ACCESSION NBR: 8011100390 DOC. DATE: 80/11/04 NOTARIZED: NO DOCKET #  
 FACIL: 50-250 Turkey Point Plant, Unit 3, Florida Power and Light C ~~05000250~~  
 50-251 Turkey Point Plant, Unit 4, Florida Power and Light C 05000251  
 AUTH. NAME AUTHOR AFFILIATION  
 UHRIG, R.E. Florida Power & Light Co.  
 RECIP. NAME RECIPIENT AFFILIATION  
 VARGA, S.A. Operating Reactors Branch 1

SUBJECT: Forwards responses to NRC 800929 request for addl info re  
 industrial exposure, offsite doses & accident evaluation.  
 Questions were discussed at public meeting between  
 respective staffs on 800917.

Re: Turkey Point Units 3 & 4  
Docket Nos. 50-250 & 50-251  
Steam Generator Repair

GENERAL LAYOUT OF BUILDINGS ASSOCIATED  
WITH HEALTH PHYSICS ACTIVITIES

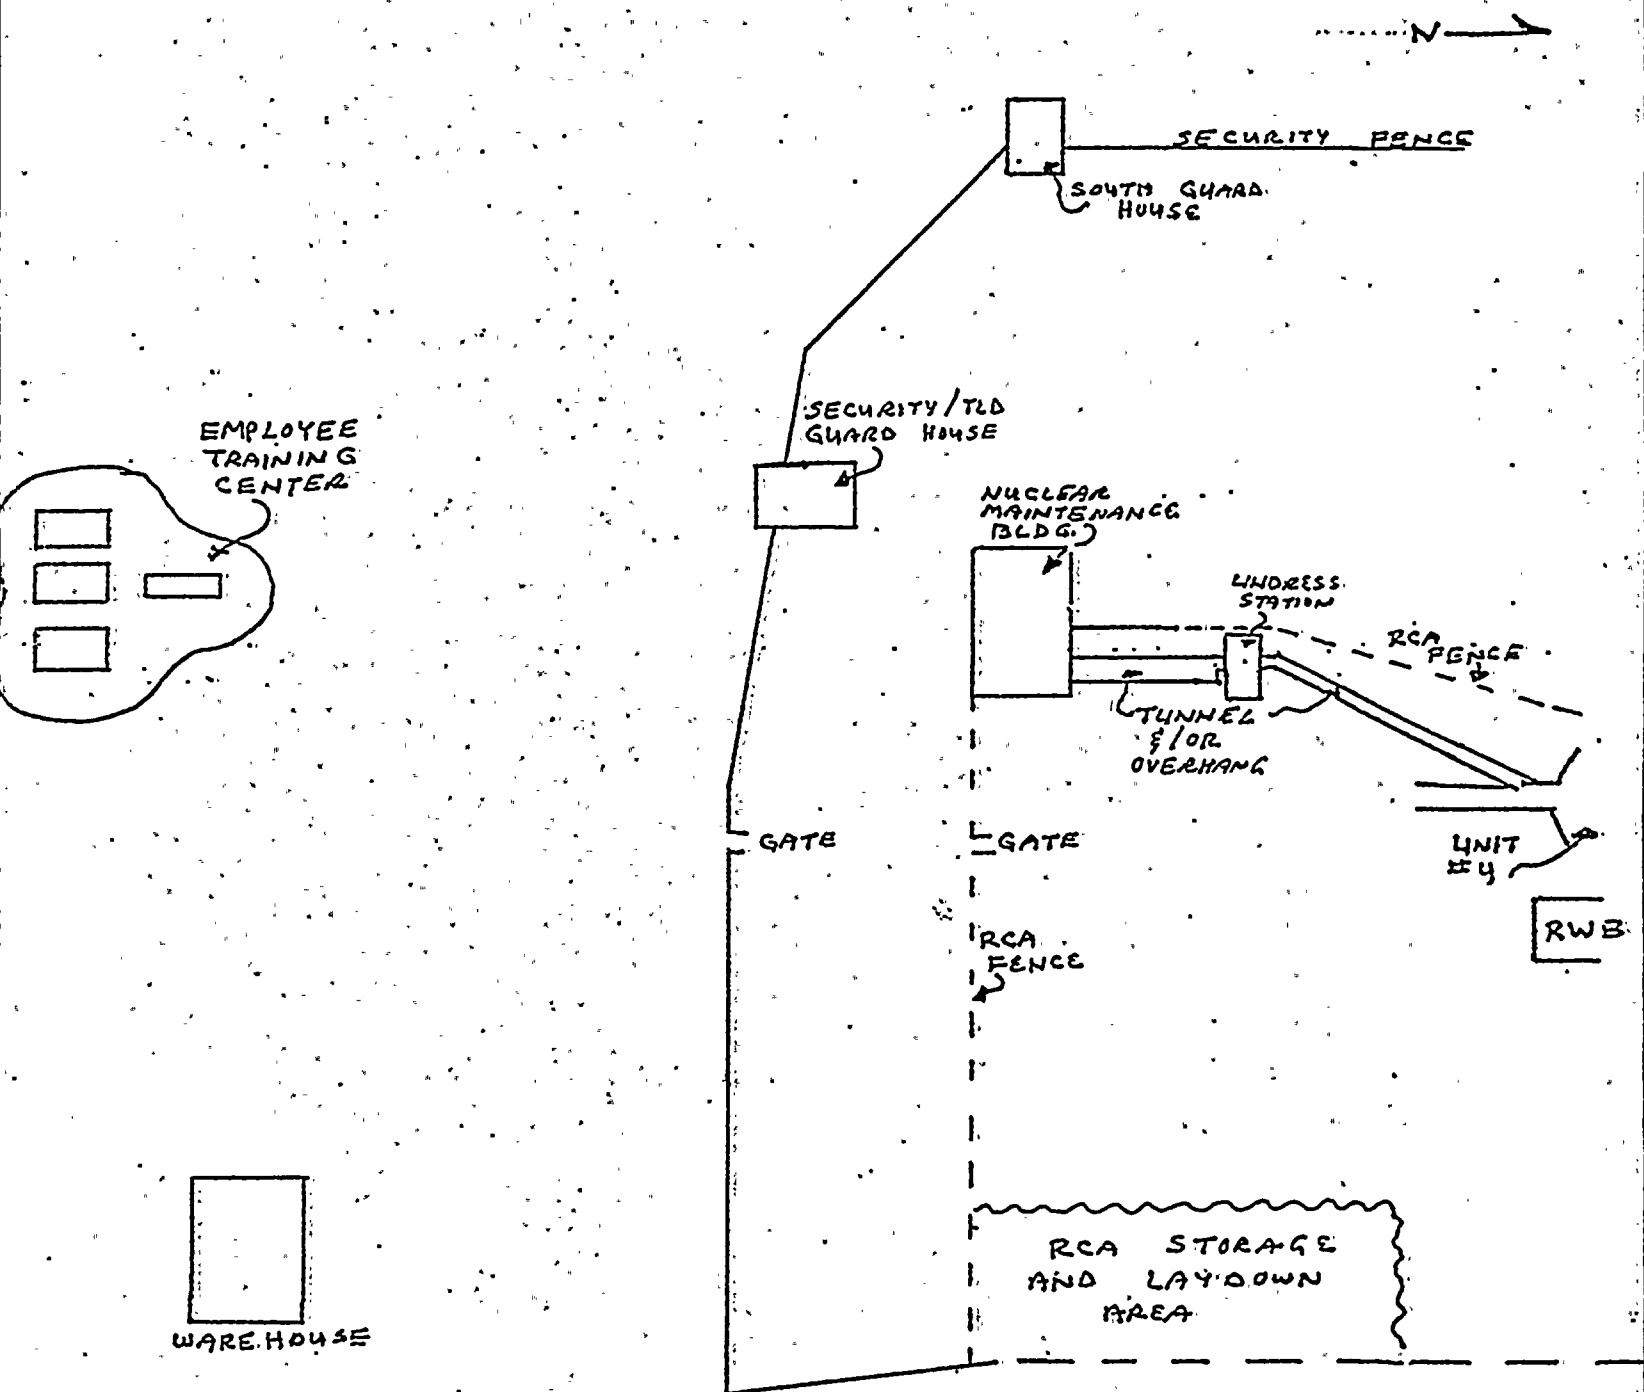
4. Your response to question 10 of our July 29, 1980 letter is incomplete. Provide a drawing showing location of new facilities including change room, access control station, laboratory facilities and decontamination facilities.

A conceptual outline (including drawings) is attached. It is for planning purposes only and is subject to change.

Figure 1 reveals the general layout for the Unit #4

Steam Generator Replacement Outage with the locations of major buildings associated with health physics activities presented. These buildings consist primarily of:

1. Employee Training Center (Figures 1 & 2)
2. Security/TLD Guard House (Figure 3)
3. Nuclear Maintenance Building (Figure 4)
4. Tunnel and/or Overhang
